Report Date: July 8, 2026
Docket No. 2026-38

Location:
1957 Norton Rd

Request:
Variance requests to
construct driveway and
new home in wetlands,
and wetland and stream
corridor setbacks

Case Manager:
Mary Rodack,
Associate Planner

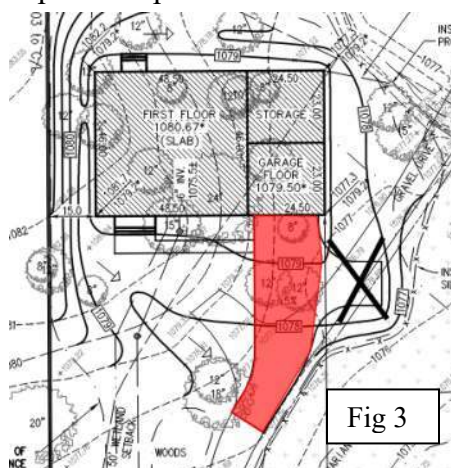
- Due to the wetlands and streams on the property, it would be difficult to build a single-family residence on the site without any variance.
- The proposed home has a footprint of approximately 3,350 square feet. The square footage of the proposed home should be reduced to minimize the impact to the wetland and stream corridor.
- The applicant should revise the site plan to remove the request to fill the wetlands. Staff notes there has been very little precedent for the BZBA approving wetland fill.
- Question if turnaround in the driveway could be revised to reduce the limits of disturbance. Figure 3 depicts the potential revision.
